RE: FERNANDEZ TOWNHOMES (J19-D40)

**SUPPLEMENTAL CALCULATIONS**  
**FOR**  
**FERNANDEZ TOWNHOMES**

**SUBJECT: CONCEPTUAL GRADING & DRAINAGE PLAN FOR  
FERNANDEZ TOWNHOUSES (J19-D40)**

**RE: FERNANDEZ TOWNHOMES (J19-D40) CONCEPTUAL GRADING AND  
DRAINAGE PLAN FOR SITE DEVELOPMENT PLAN FOR BUILDING PERMIT  
APPROVAL. ENGINEER'S STAMP DATED 10-30-95.**

TYP EASEMENT CHANNEL

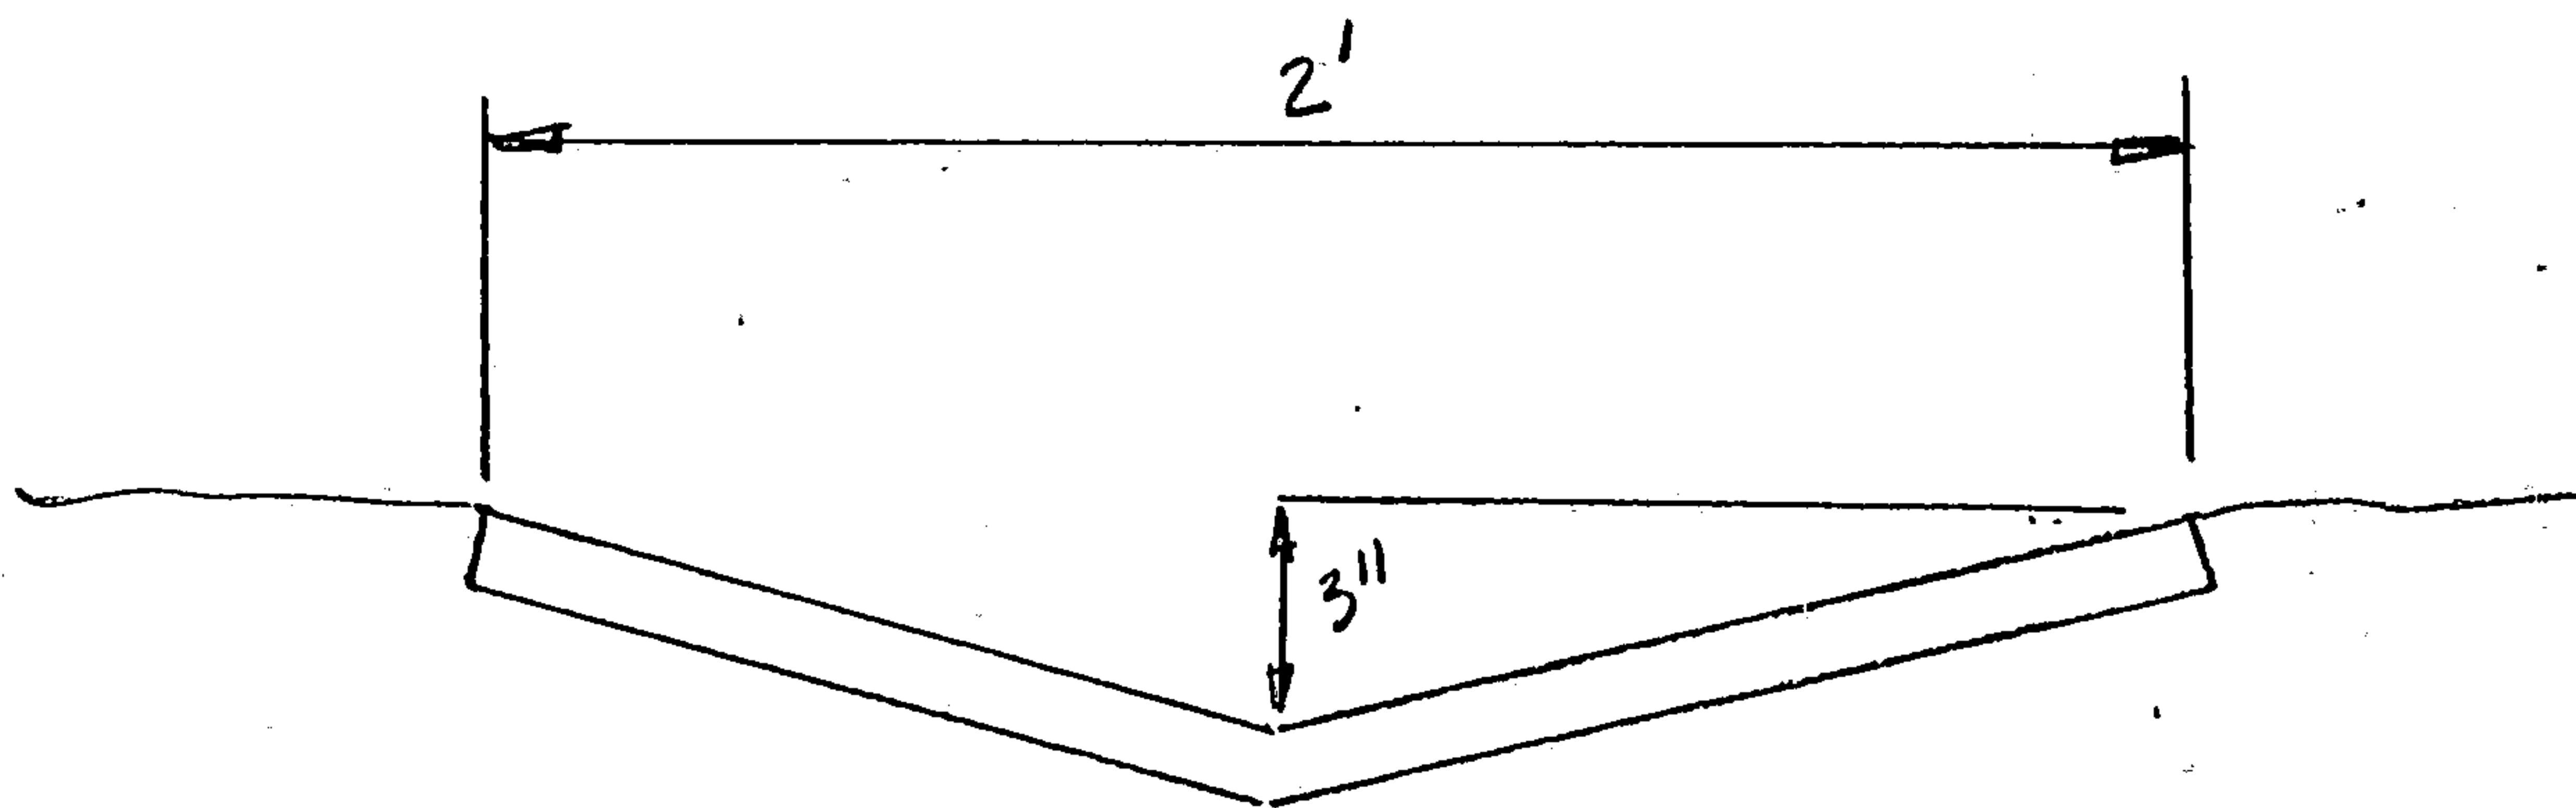
BASIN 'B'  $Q_{100} = 0.1$  CFS

BASIN 'C'  $Q_{100} = 0.5$  CFS

$Q_{MAX} = 0.7$  CFS

TYP S/W CULVERT CHANNEL

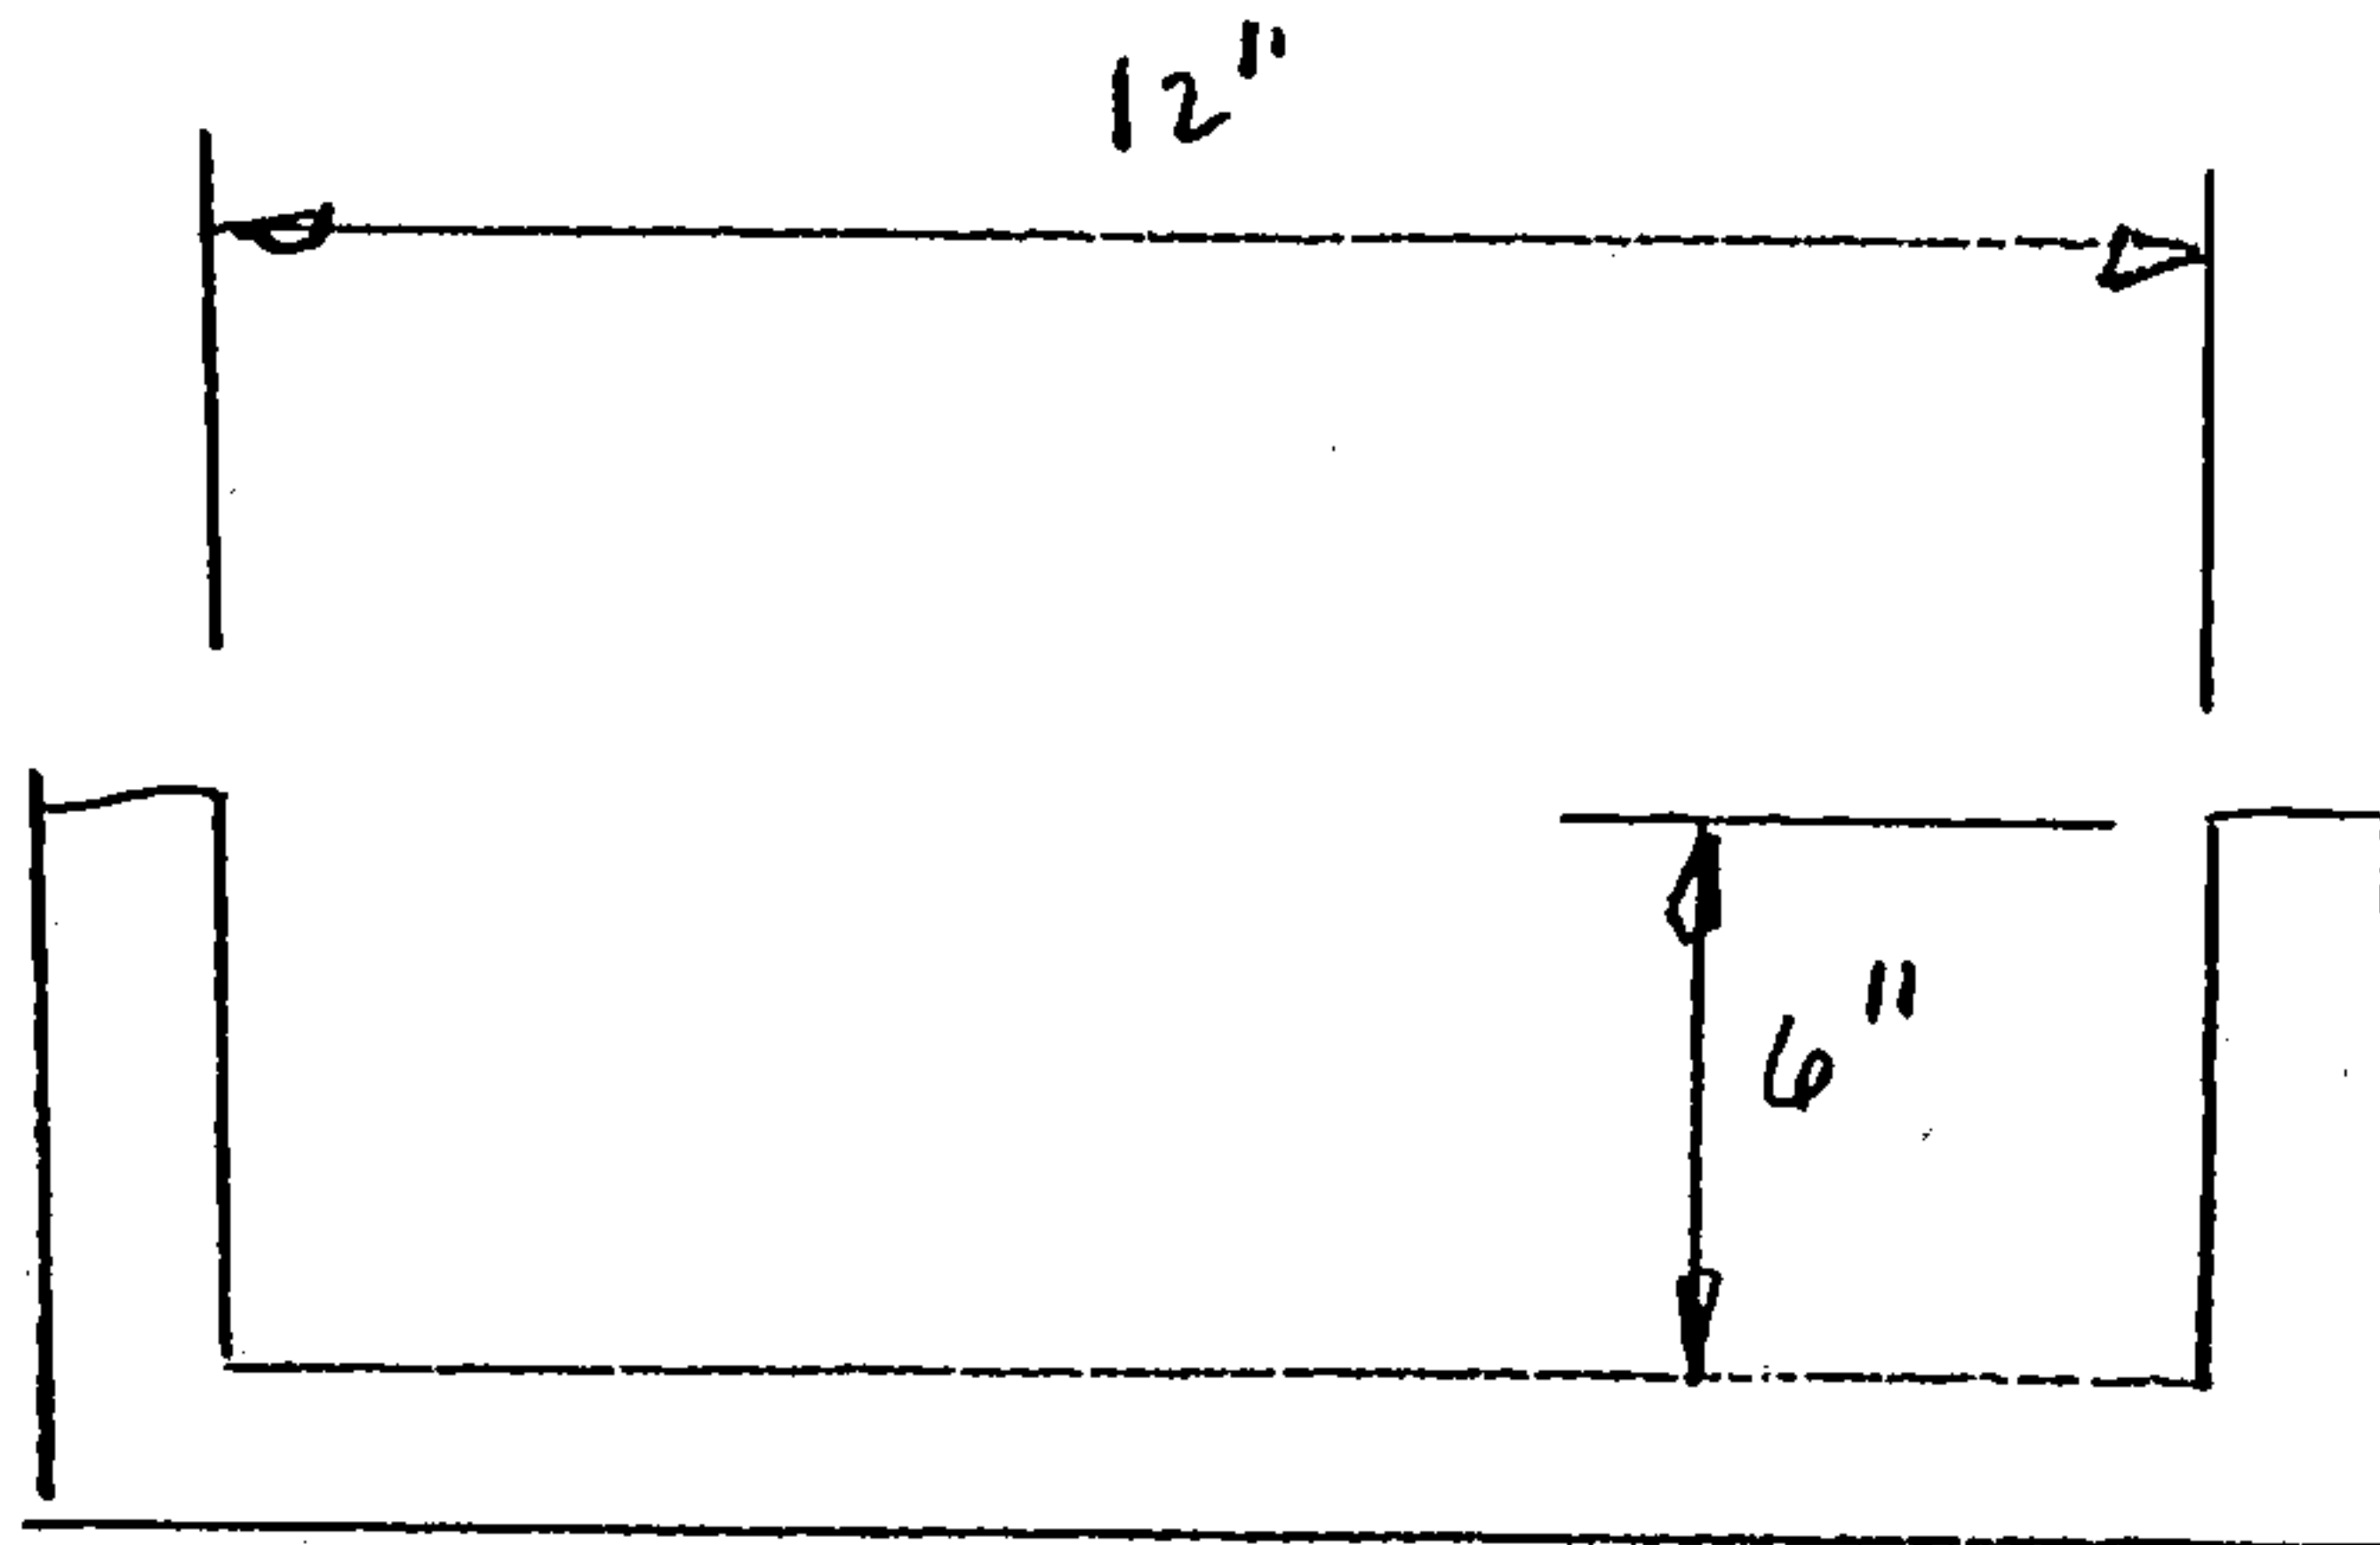
BASIN 'B'

$Q_{100} = 0.1$  CFS

BASIN 'C'

$Q_{100} = 0.5$  CFS

$Q_{MAX} = 2.27$  CFS
